## Access Compliance Report Public Rights-of-Way (Curb Ramps)

Intersection ID: 10025502Main Street:E\_MOREHEAD\_STCross Street:N/ALocation:NWADA ID: A4BE27EE96D7Ramp Type:PerpInitial Pass/Fail:FailOverall Compliance:NoSeverity Score:10

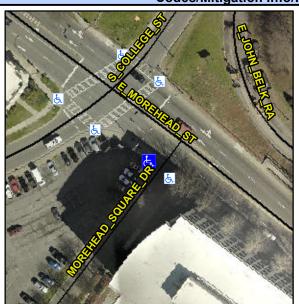
Possible Solution	
Possible Solutions:	9
Remove & Replace Entire Ramp.	ı
, ,	ı
	1
	ı
	ı
	ı
Surveyor Notes:	ı
N/A	ı
	ı
	ı
	ı
PROW/ADA:	ı
Not Found, R304.5.1, R304.5.3	1
	ı
	ı

Field Measurements/Component Compliance						
Compliance Description		Data	Comp	liance Description	Data	
N/A	Ramp Length (in)	33.0	Yes	Ramp Slope (%)	7.1	
No	Ramp Width (in)	47.0	No	Ramp XSlope (%)	3.0	
N/A	Flare Type LT	N/A	N/A	Flare Type RT	N/A	
N/A	Flare Slope LT (%)	N/A	N/A	Flare Slope RT (%)	N/A	
N/A	Flare Traversable LT?	N/A	N/A	Flare Traversable RT?	N/A	
N/A	Landing Length (in)	N/A	N/A	DWS Provided?	N/A	
N/A	Landing Width (in)	N/A	N/A	DWS Contrast?	N/A	
N/A	Landing Slope (%)	N/A	N/A	DWS Length (in)	N/A	
N/A	Landing X Slope (%)	N/A	N/A	DWS Full Width?	N/A	
N/A	Landing Curb? (Y/N)	N/A	N/A	DWS Offset (in)	N/A	
N/A	Shared Landing?	N/A				
N/A	Gutter Ponding?	N/A	N/A	Gutter Slope (%)	N/A	
N/A	Gutter Lip Ht (in)	N/A	N/A	Gutter X Slope (%)	N/A	
N/A	Painted X Walk1?	No	N/A	Painted X Walk2?	N/A	
	X Walk 1 Direction	To SE		X Walk 2 Direction	N/A	
N/A	X Walk 1 Width (in)	N/A	N/A	X Walk 2 Width (in)	N/A	
	X Walk 1 Slope (%)	1.9		X Walk 2 Slope (%)	N/A
